**From:** [Rosseel, Thomas M.](#)  
**To:** [Hiser, Matthew](#)  
**Cc:** [Gerard Van Noordennen](#)  
**Subject:** [External\_Sender] Re: Ex-plant Materials Harvesting Workshop  
**Date:** Wednesday, June 21, 2017 4:35:05 PM  
**Attachments:** [Harvesting Workshop Draft Summary Report.TR.docx](#)

I would like to share for your review and comment the workshop summary report (attached). In the report, we tried to capture as much of the discussion as possible, while focusing on the key takeaways that might be useful for all participants as they consider harvesting in the future. In particular, please review how your presentation and contribution to the discussion is characterized, in case you feel it should be clarified in any way. Feel free to provide additional references to previous research on harvested materials that should be captured in this report. Comments, edits, and suggestions on any other parts of the report are welcome.

# **Ex-Plant Materials Harvesting Workshop Summary Report**

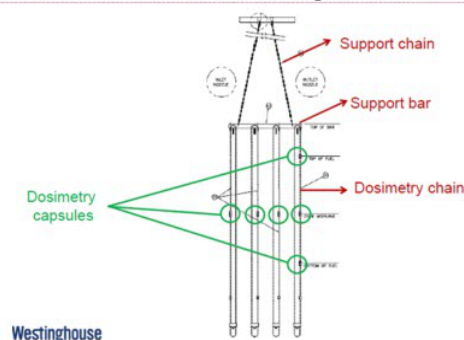
**Commented [HA12]:** Nice illustration, do you want to call it Figure 1 with a cross-referencw with the narrative?

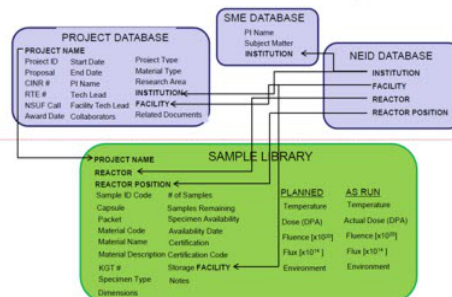
Commented [HA15]: Nice illustration, maybe cross-reference as Figure 2 with caption and call-out in text.
